**ADDENDUM #5**

**Will County Health Department**  
**BID PACKAGE #2 – Misc. Steel/Structural/Enclosure**  
**November 15, 2018**

**SECTION 00 91 07  
BP #2 - ADDENDUM NUMBER 5**

**PROJECT:**           **WILL COUNTY HEALTH DEPARTMENT - NEW HEALTH DEPARTMENT  
BUILDING  
501 ELLA AVENUE  
JOLIET, ILLINOIS 60433**

A1202

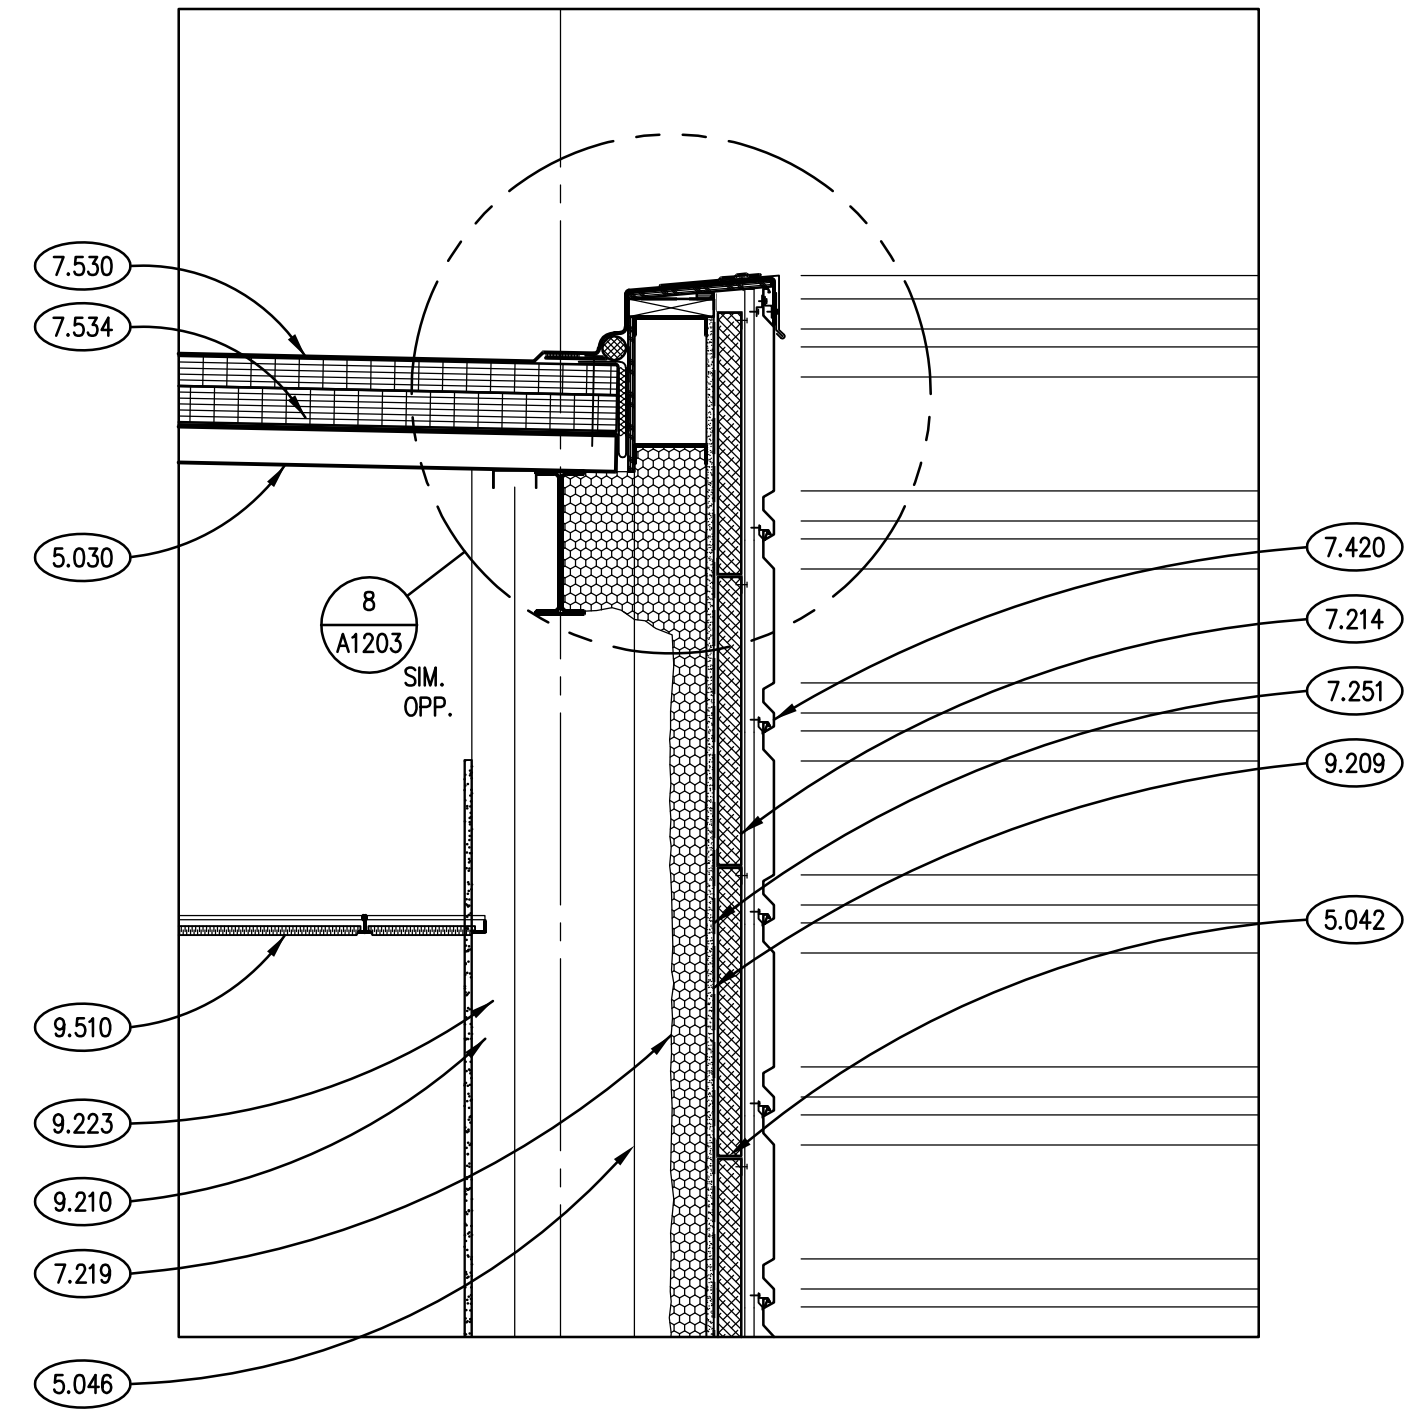
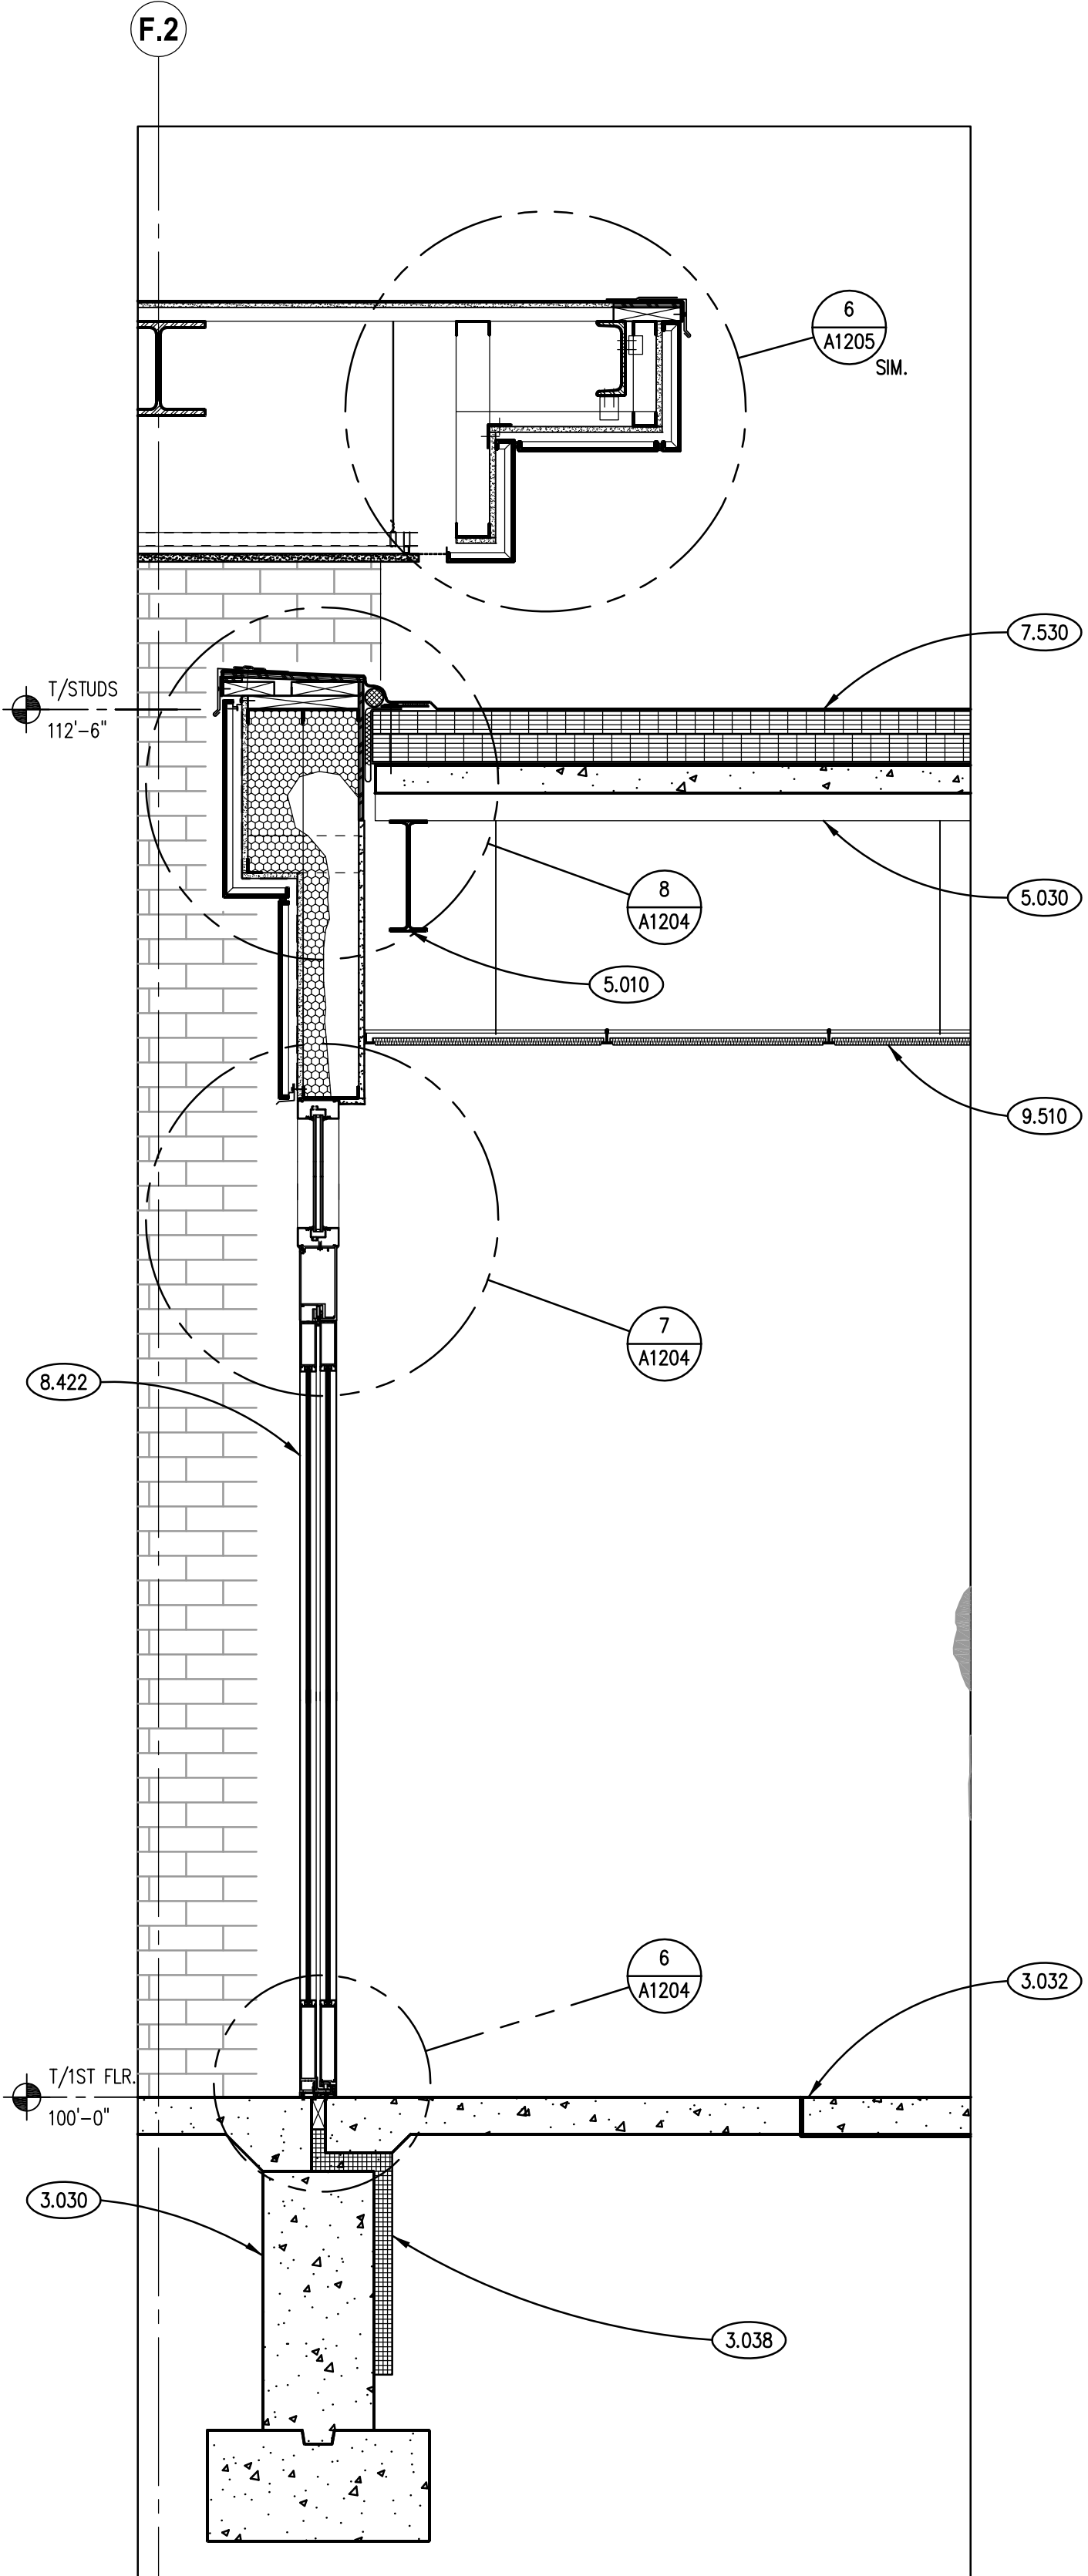
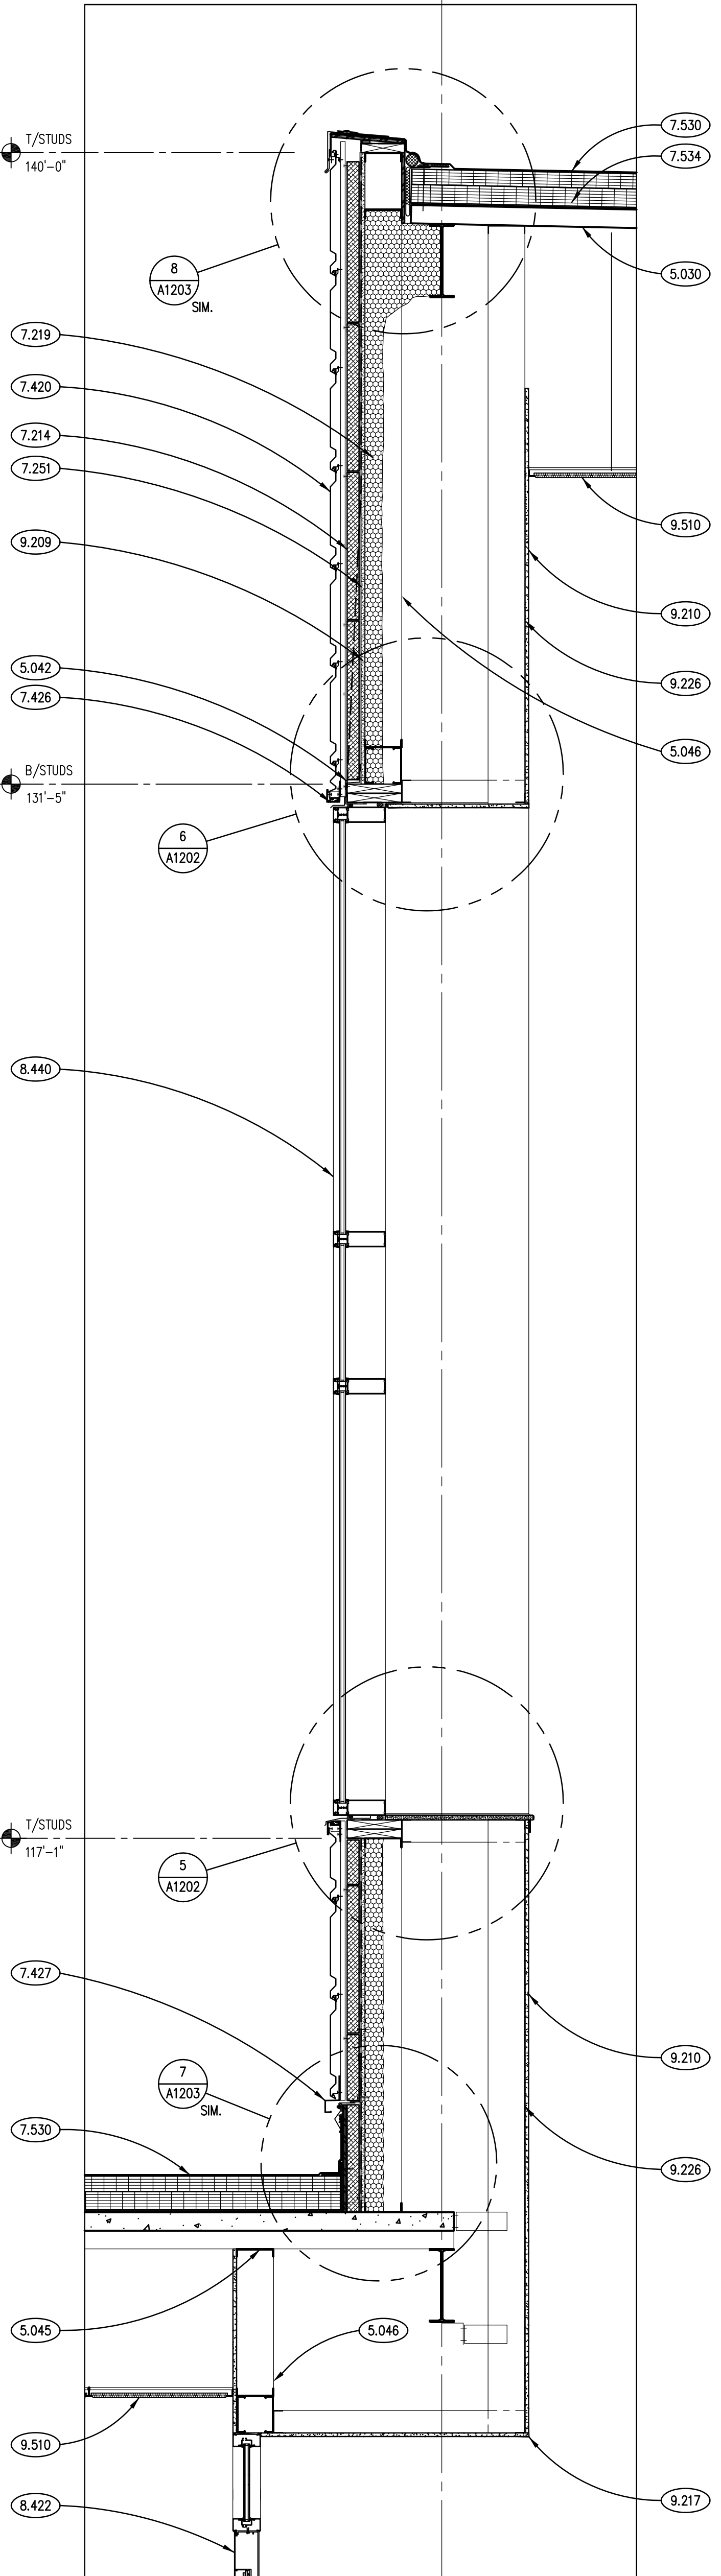
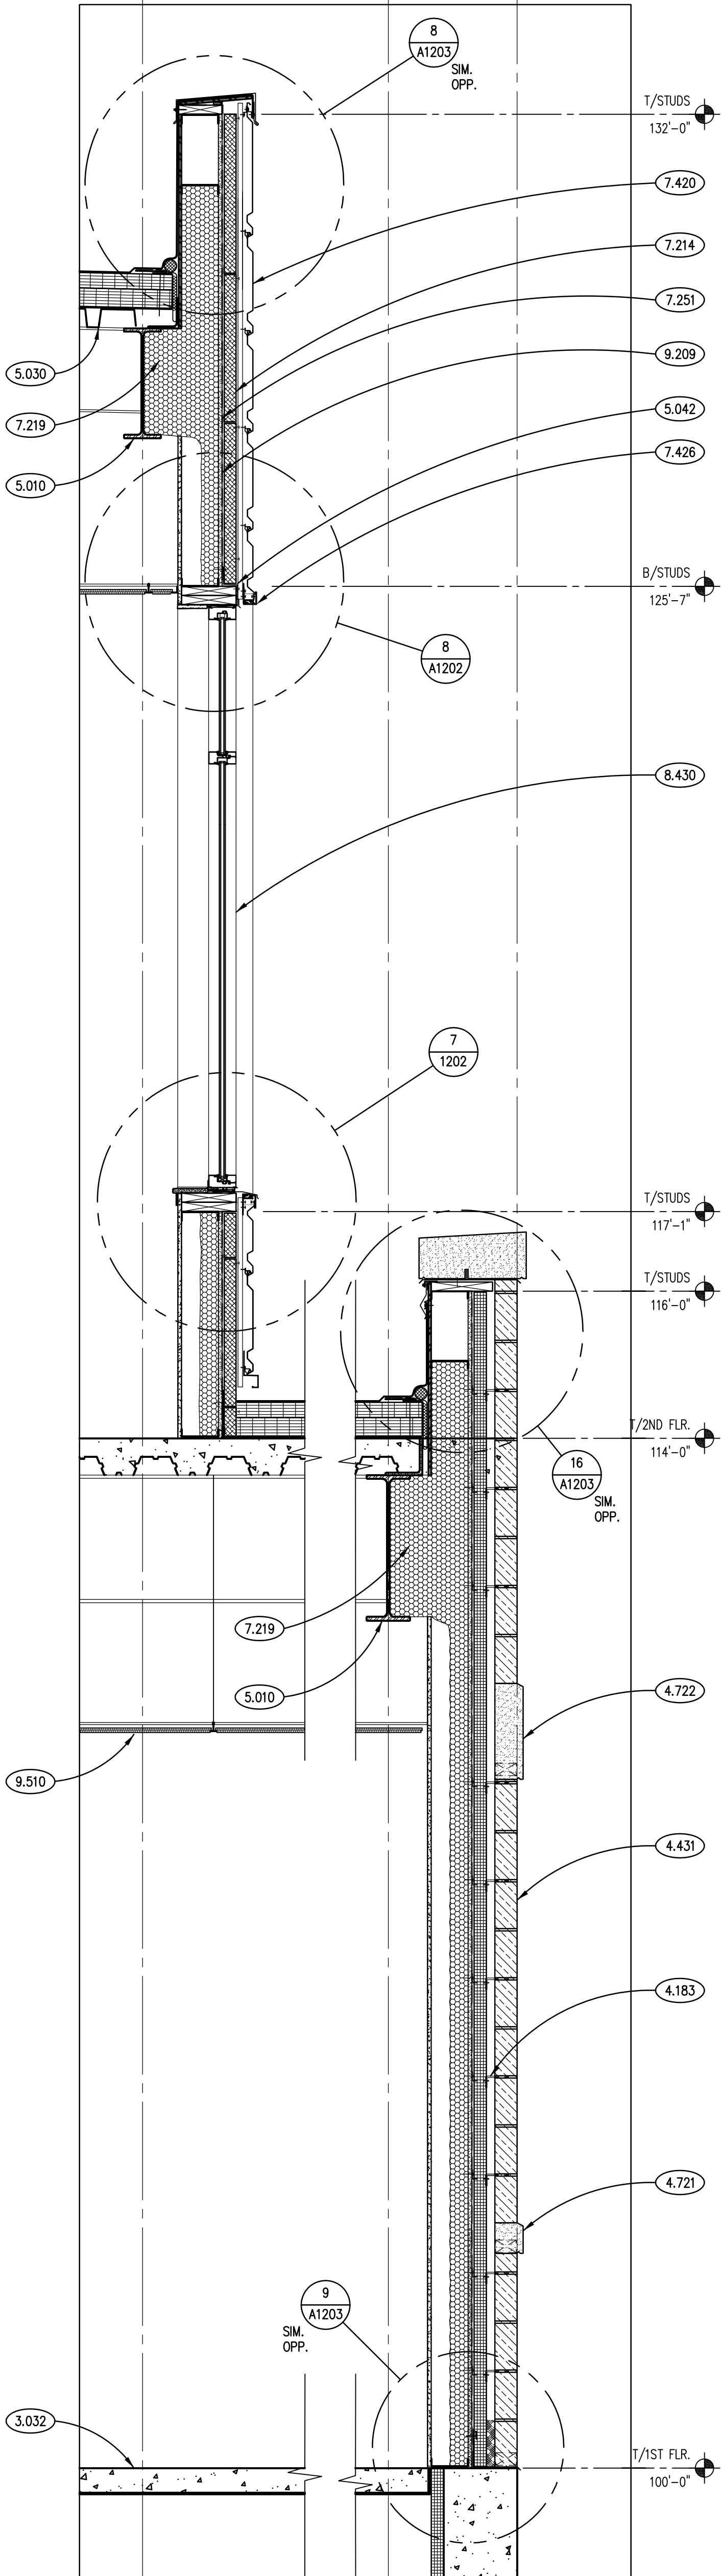
- A. Revisions to the weather barrier coating placement and termination points. Minor modifications to the details as noted. Refer to revision cloud 9 for specific changes.
- B. Added General Note #6.
